South Texas Project Electric Generating Station P.O. Box 289 Wadsworth, Texas 77483

South Texas Project
Units 1 and 2
Docket Nos. STN 50-498 and STN 50-499

Proposed License Amendment Concerning Radiological Aspects of Operation at Reduced Feedwater Temperature and of Operation with Replacement Steam Generators

Figure 5.5-1

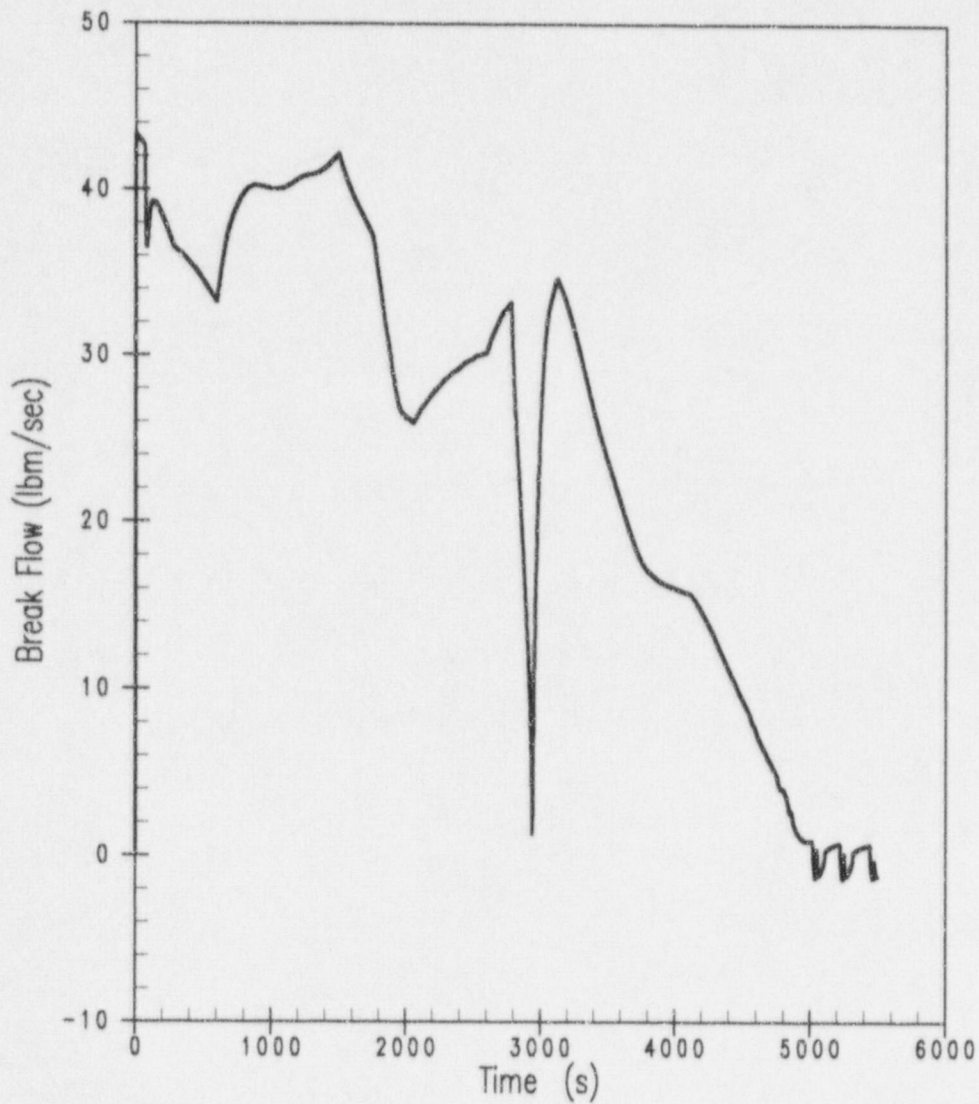
SOUTH TEXAS UNIT 1 STEAM GENERATOR TUBE RUPTURE
OFFSITE DOSE ANALYSIS
PRIMARY TO SECONDARY BREAK FLOW
